DECISION OF THE PLANNING ADMINISTRATOR

**TREE REGULATION VARIANCE / CLASS 2 DRIVEWAY APPROACH PERMIT
CASE NO.: TRV-DAP25-01**

APPLICATION NO.: 24-125192-PLN

SUMMARY: Four Tree Regulation Variances and a Class 2 Driveway Approach Permit for development of a cottage cluster.

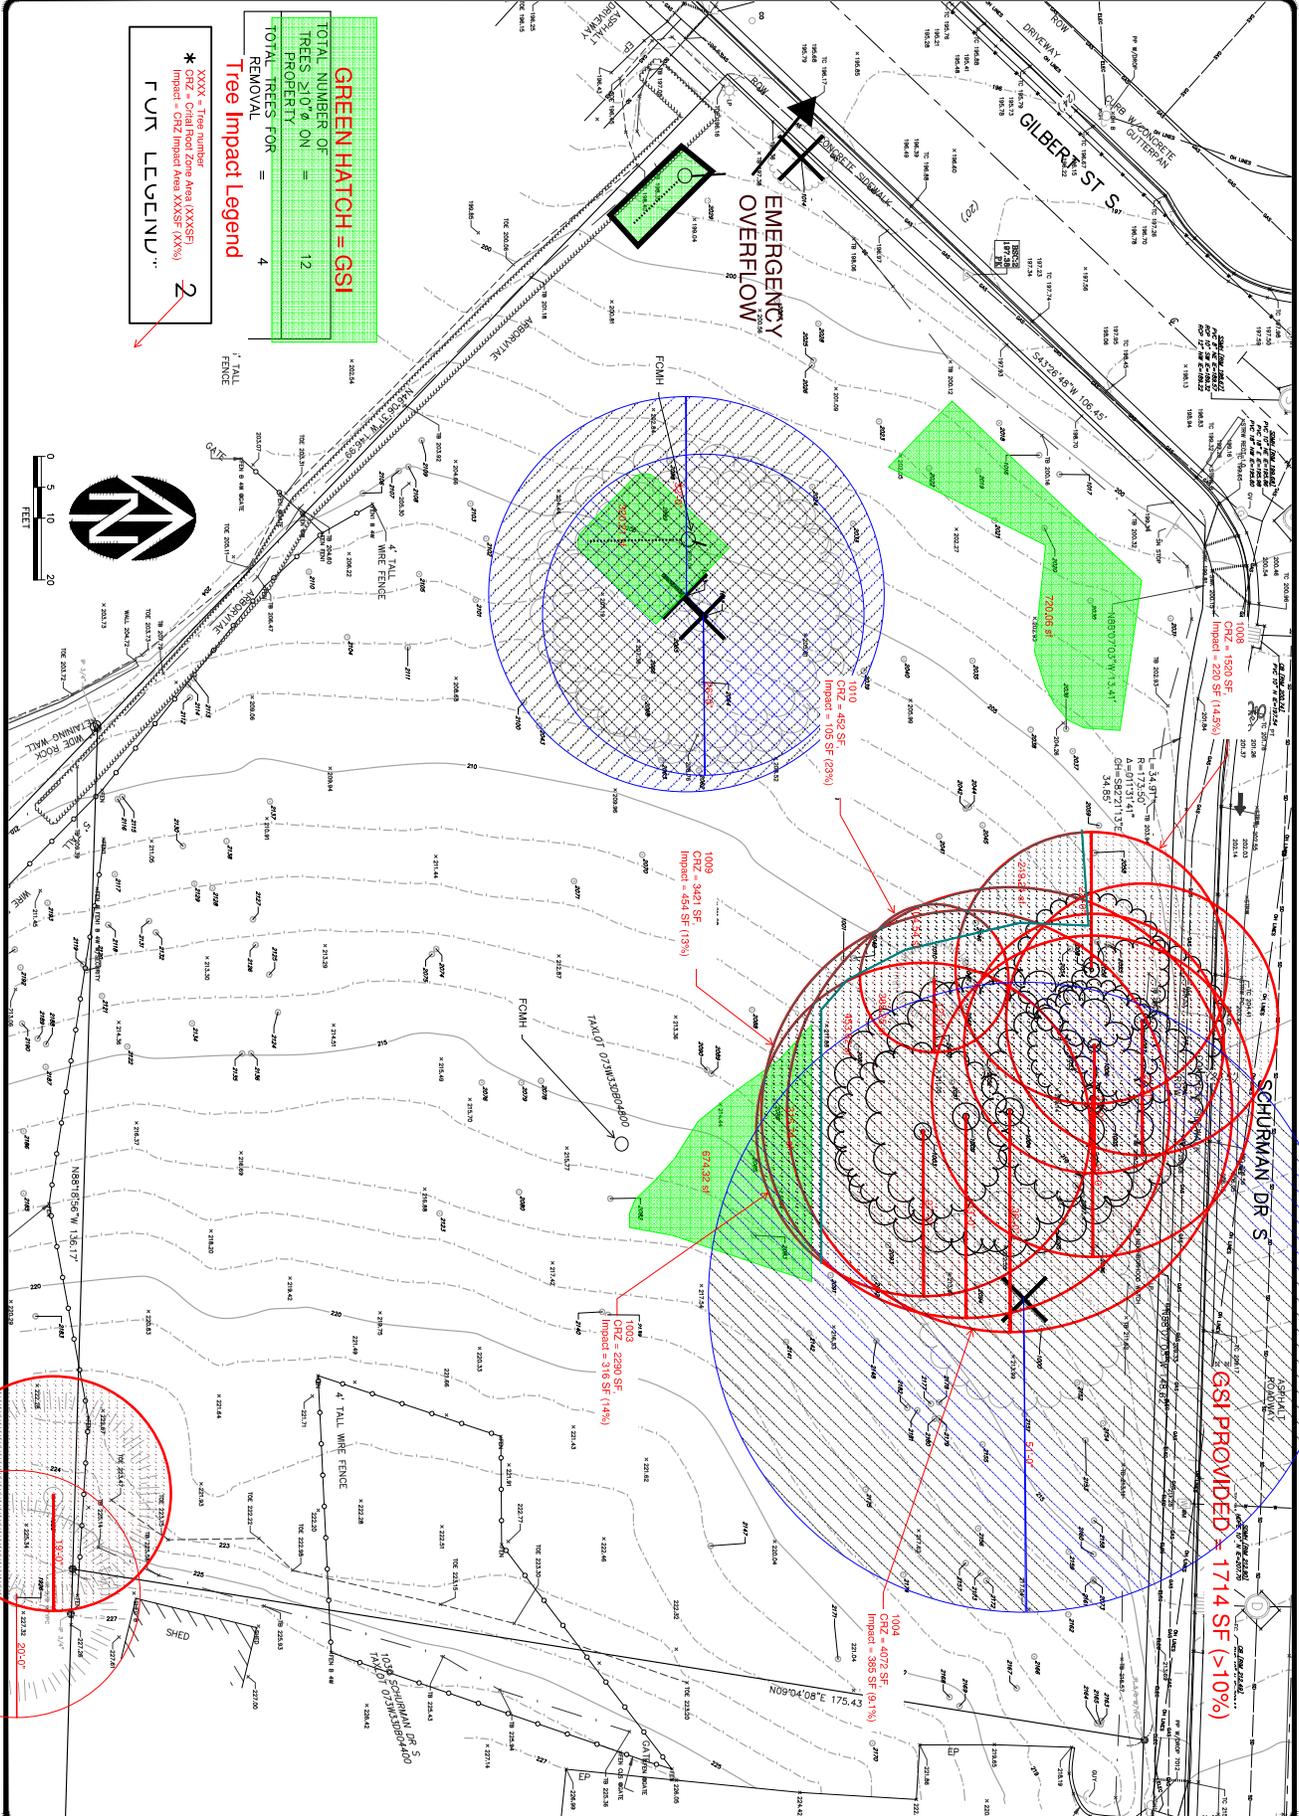
Staff Response: The Neighborhood Association provided comments indicating their opposition to the removal of the three Oregon White Oak trees (trees 1011, 1012, and 1013 on the plans). The response asserts that the applicant has not demonstrated they have met the approval criteria of a tree variance under SRC 808.045(d)(1). The comments indicate that tree 1011 is within the critical root zone of the many other significant trees on the site, which are proposed for preservation, and that extending the protection area around those trees could include tree 1011. The applicant has requested to encroach within 30 percent of the critical root zone of tree 1011, which meets the definition of removal; however, the applicant proposes to keep this tree, which is addressed further in the findings included in this decision. The comments also suggest the parking area could be redesigned around trees 1012 and 1013, enabling them to be preserved. The applicant has responded that due to the site's steep topography, significant grading will be necessary for the development of the proposed parking

For the first two Tree Variance requests, the applicant has proposed to remove two trees, a 26-inch and a 32-inch Oregon White Oak (trees 1012 and 1013 on the plan), for the development of a proposed driveway and off-street parking area to serve the units. While off-street parking is not required for the proposed cottage cluster use, the applicant has proposed development of 11 off-street parking spaces to serve the units. Per the Special Use development standards of a cottage cluster under SRC 700.011(f), off-street parking areas shall not be located between the front property line abutting a street and those dwelling units within the cottage cluster that are located closest to the front property line abutting a street, unless the lot is a corner lot, then the off-street parking area may be located between the dwelling units and a side lot line abutting a street. The property is a corner lot abutting Schurman Drive S and Gilbert Street S; therefore, the front property line can be either street-abutting property line, provided it meets lot standards.

- Condition 2:** A licensed arborist shall be on site to conduct any excavating and cutting of the roots of the significant Oregon White Oaks on the property (trees 1003, 1004, 1005, 1006, 1007, 1008, 1009, and 1011 on the attached plan).

Finding: The preliminary site plan shows a retaining wall within the required vision clearance area for the Driveway Approach. The site plan does not provide details regarding the height of the retaining wall. SRC 805.010 prohibits obstructions to vision clearance from 30 inches above curb level to 8.5 feet above curb level; it is unclear from the information provided if the retaining wall complies with the 30-inch height restriction. As a condition of approval, prior to building permit issuance the applicant shall submit a site plan demonstrating the driveway approach serving the proposed cottage cluster development complies with applicable Vision Clearance Standards in SRC Chapter 805. With this condition of approval, the driveway approach will comply with the Vision Clearance Standards established in SRC Chapter 805.

- Condition 1:** At time of building permit, the applicant shall provide a report from a licensed arborist demonstrating the proposed development will not adversely impact tree 1011.

- Condition 3:** During construction, an above ground silt fence or its equivalent shall encompass 100 percent of the critical root zone of the significant Oregon White Oaks, except where the arborist's report indicates less than 30 percent of the critical root zones will be impacted. Within the area protected by the above ground silt fence, the tree's trunk, roots, branches, and soil shall be protected to ensure the health and stability of the tree; and there shall be no grading, placement of fill, storage of building materials, or parking of vehicles.

Condition 4: Prior to building permit issuance, the applicant shall submit a site plan that demonstrates the proposed driveway approach serving the development is in compliance with applicable vision clearance requirements of SRC Chapter 805.
